FINAL PLAT

FOX POINTE SECOND ADDITION

Re: S/D 95-74 - FOX POINTE SECOND ADDITION (Final Plat)

CASE NUMBER: S/D 95-74 FOX POINTE SECOND ADDITION

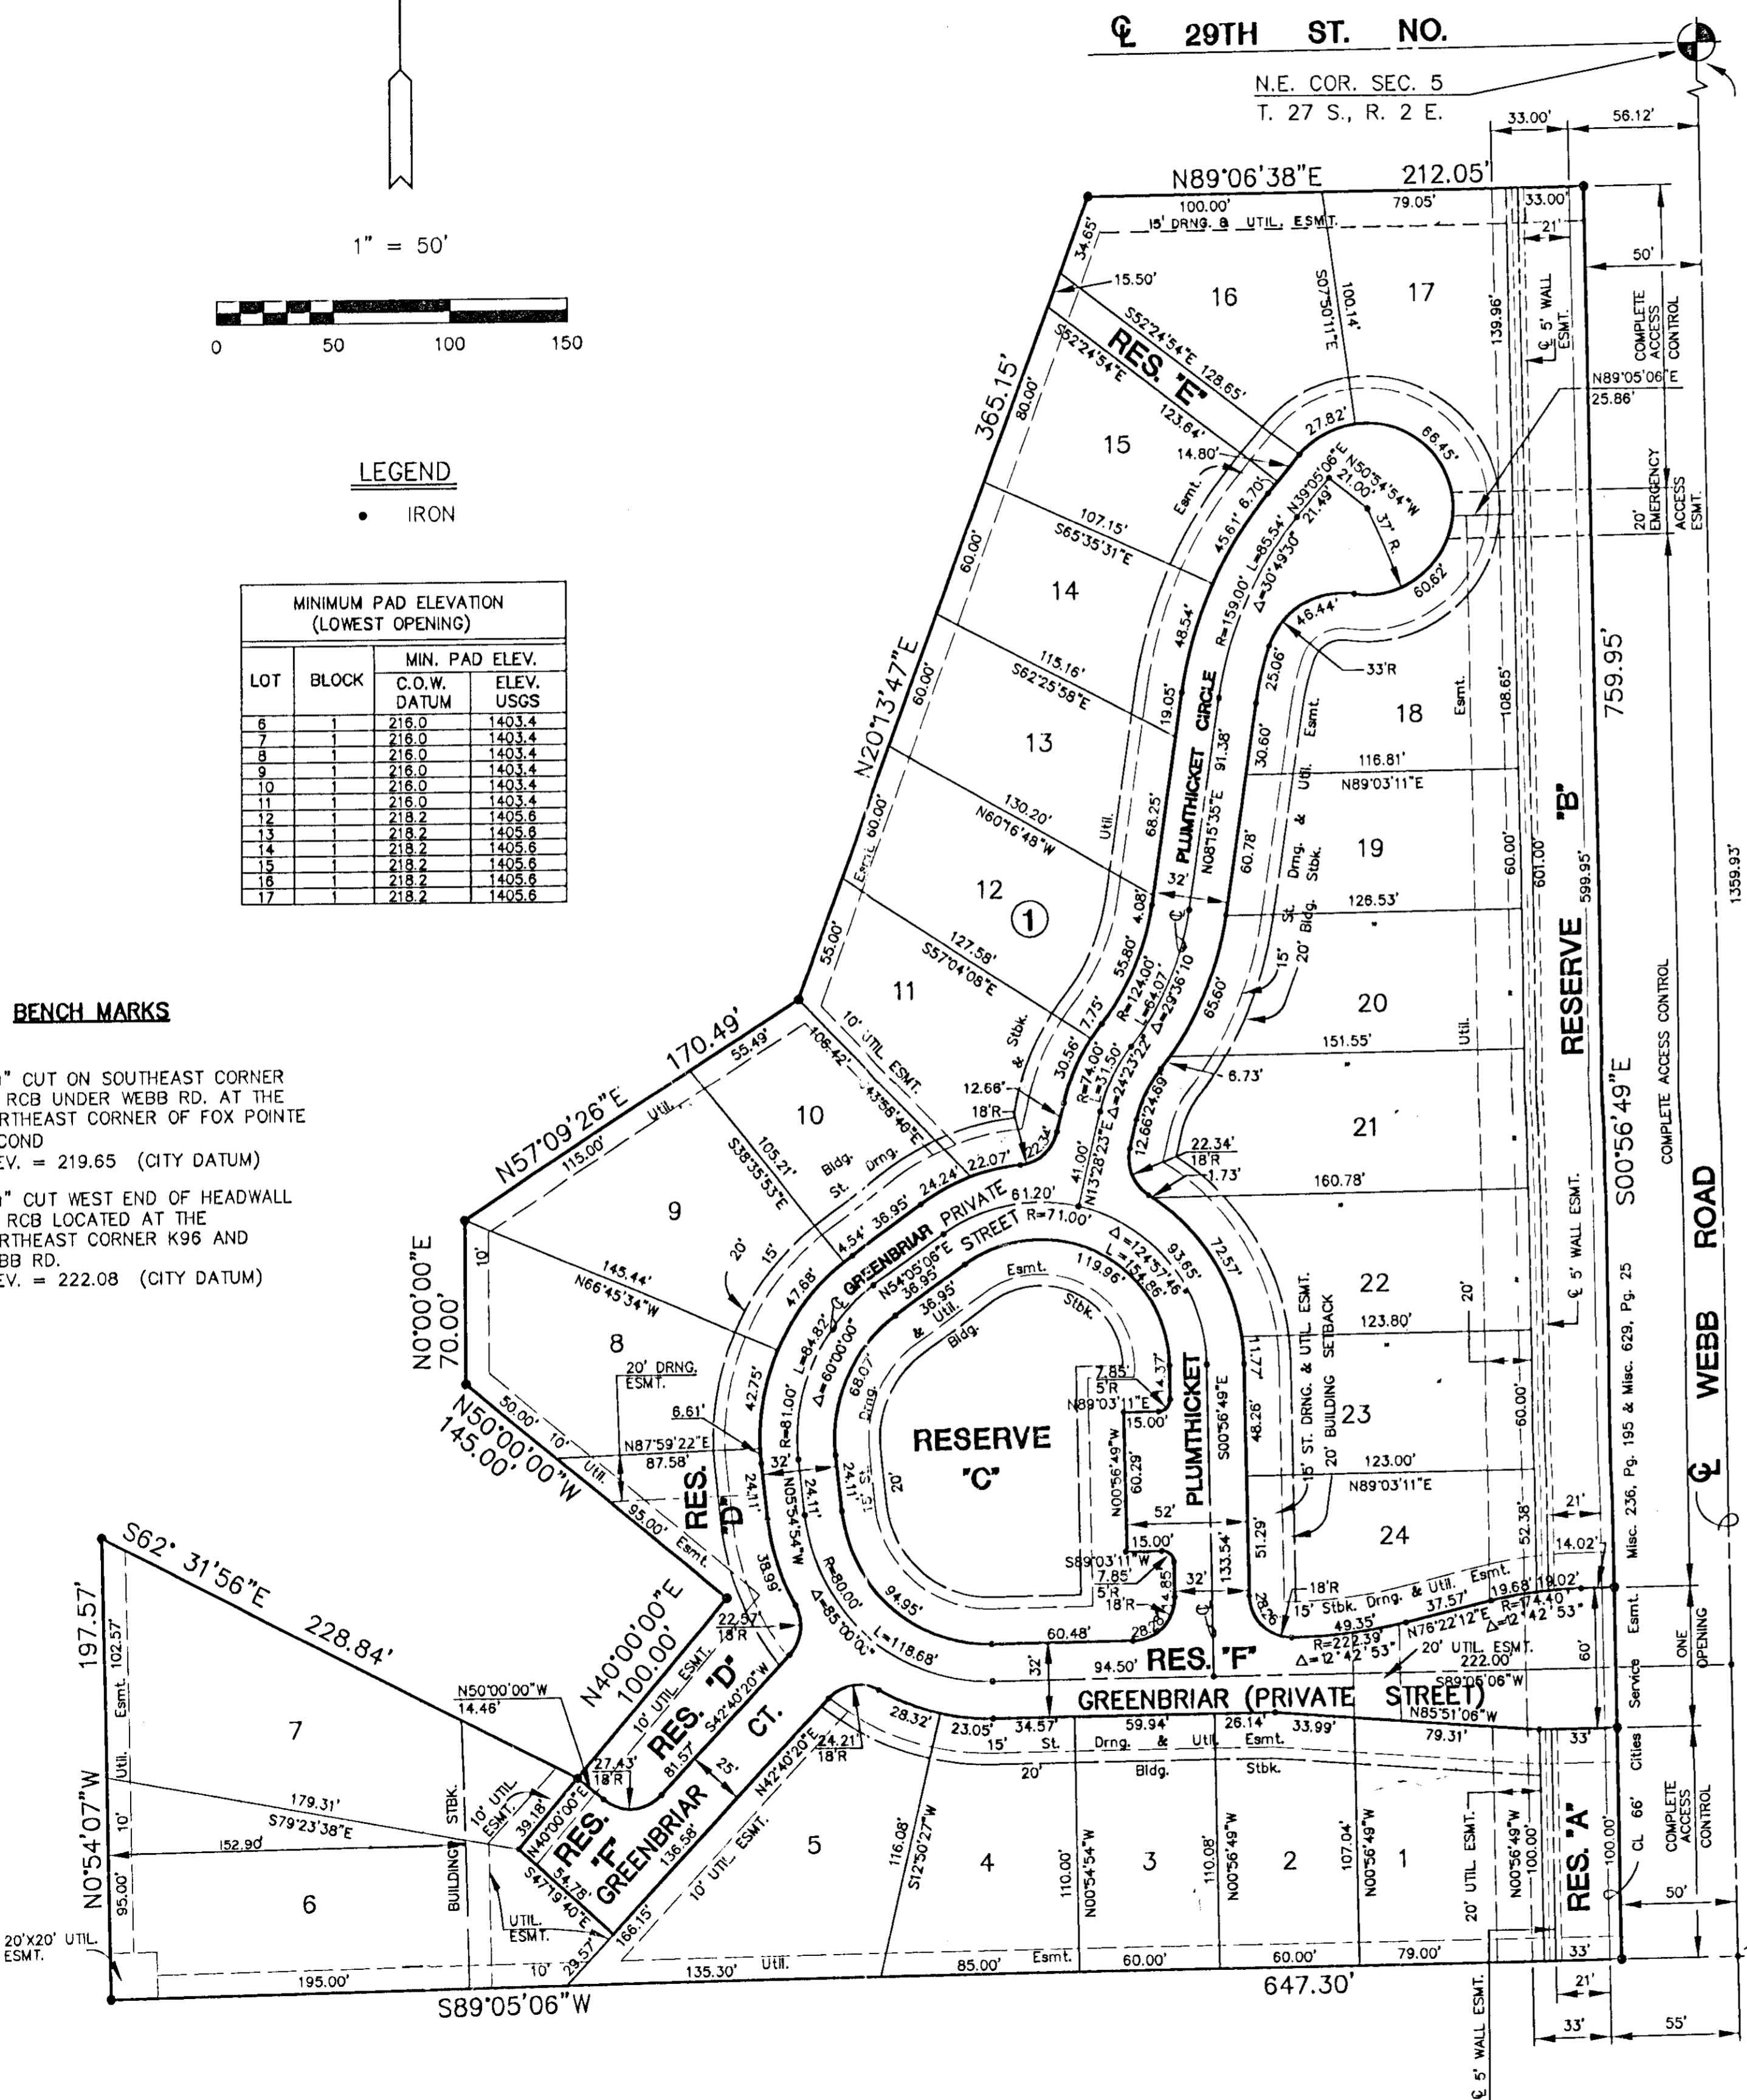
~~C.~~ *As shown*
As this property is establishing minimum building pad elevations, the face of the final plat tracing shall reference the location and elevation of permanent on-site and off-site benchmarks. Section 5-402(N).

~~G.~~ On the final plat tracing, the surveyor's text shall be corrected to note that the drainage easement being vacated appears to have been recorded on Film 1131 not 131 *OK*

~~CC.~~ *extended as needed or more*
The final plat shall indicate the utility easements requested by K.G. & E.-Gas and K.G. & E.-Electric which are indicated on the enclosed "marked" copy of the plat.

~~DD.~~ *OK - Utility - they are now going to use an existing plat for above as originally*
As indicated by City Engineering, the final plat tracing shall indicate an enlarged drainage easement along the plat's northern line. Further, an off-site drainage easement will be required and needs to be provided by separate instrument. This easement shall be submitted to Engineering for review, then to Planning for recording with the plat. *platted*

OK w/ Utility as a total P. to put easement along northern line => as off-site easement if easements and/or a Reserve on the adjoining plat allow for utilities then it appears that only the easement at the rear of Lots 8, 9, and 10 may need to be enlarged or in the area of an adjacent lake. If the adjoining plat does not provide additional utility easement, then other lots will also need to increase the size of easement to be platted.
